# UNITED STATES PATENT AND TRADEMARK OFFICE

APPLICATION NO.	FILING DATE	FIRST NAMED INVENTOR	ATTORNEY DOCKET NO.	CONFIRMATION NO.
10/067,218	02/07/2002	Dan A. Steinberg		6453

## Office Action Summary

**DETAILED ACTION**

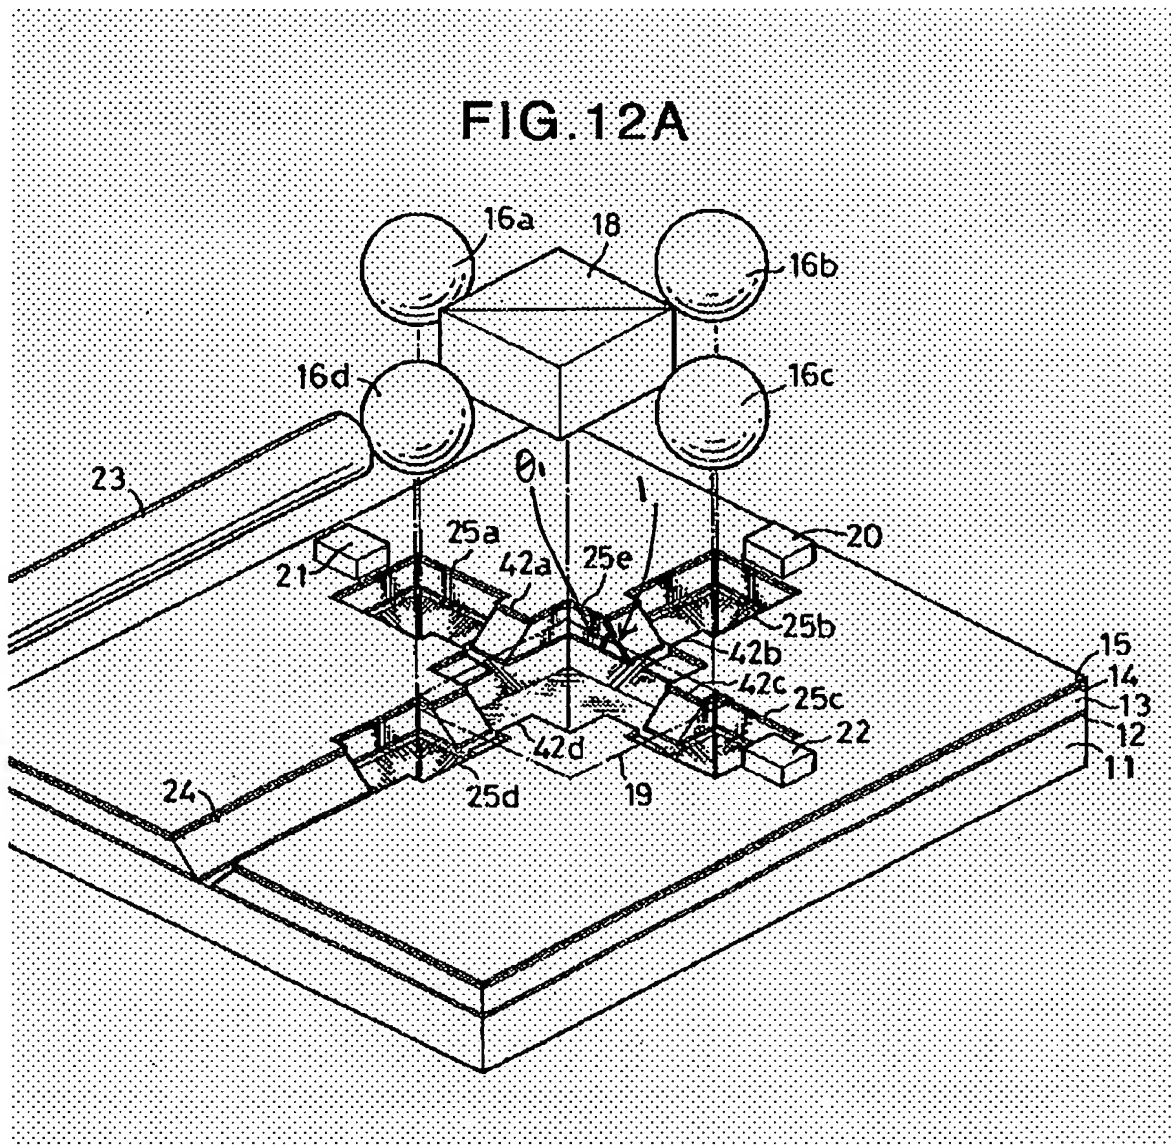
Applicant's arguments filed 12/30/04 have been fully considered but they are not persuasive. Applicant argues that Tabuchi does not disclose or suggest first and second wet-etched groove sections each having a sidewall that intersects a respective side of

the pit at a non-orthogonal angle relative to a longitudinal axis of the respective groove section.

Examiner does not agree with Applicant's argument because Tabuchi clearly shows the sidewall that intersects a respective side of the pit at a non-orthogonal angle relative to a longitudinal axis of the respective groove section. See the arrow 1 in the pasted drawing of Fig. 12A. The line of arrow 1 is formed by the sidewall of the groove and the sidewall of the pit. The line of arrow 1 is clearly non-orthogonal to the longitudinal axis of the groove section, and the angle  $\theta_1 < 90^\circ$  is formed by the line of arrow 1 and the longitudinal axis of the groove section.

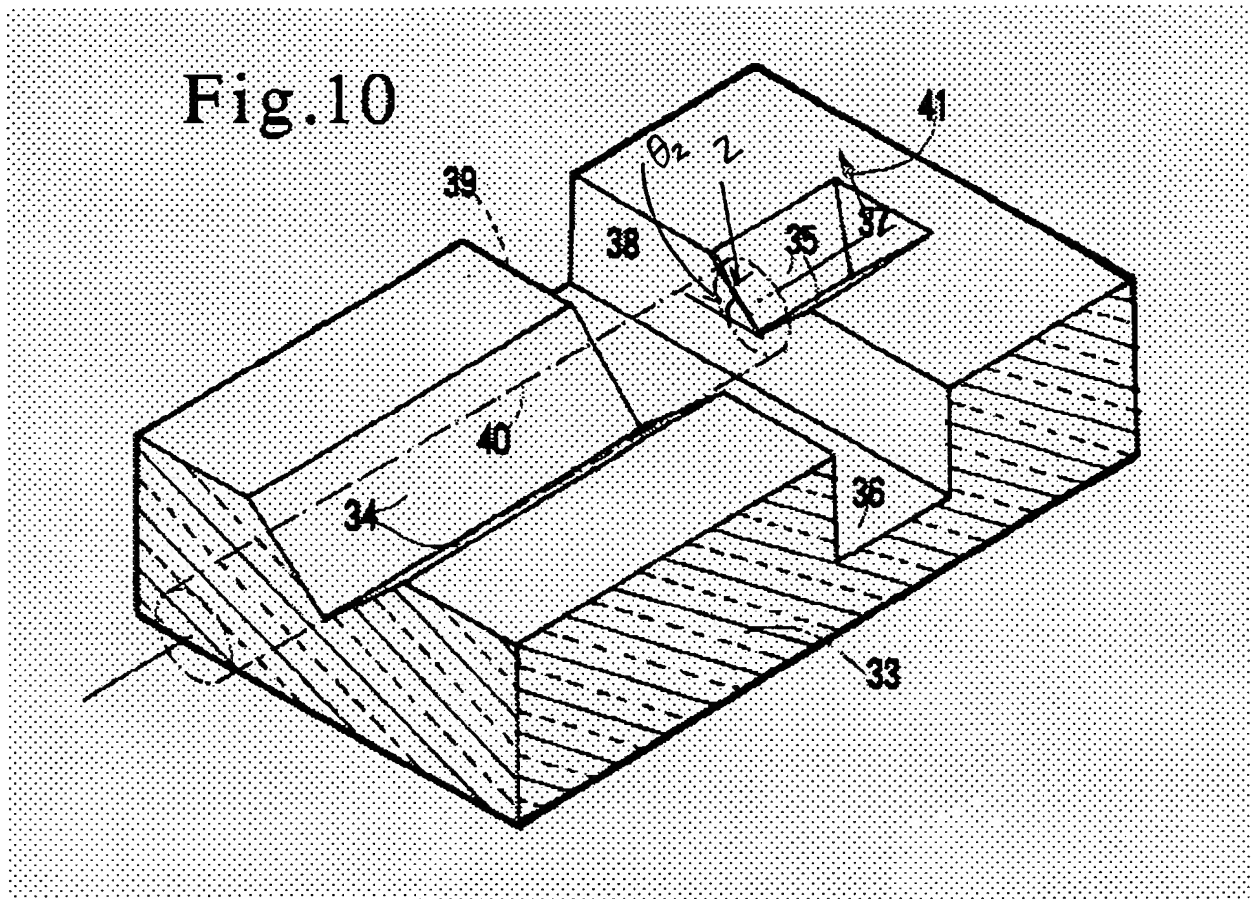
Applicant further argues that Nakanishi does not disclose or suggest the non-orthogonal angle. See the line of arrow 2 in the pasted drawing of Fig. 10 below. The line of arrow 2 is formed by the sidewall of the groove 35 and the sidewall of the pit 36. Again the angle  $\theta_2 < 90^\circ$  is formed by the line of arrow 2 and the longitudinal axis of the groove.
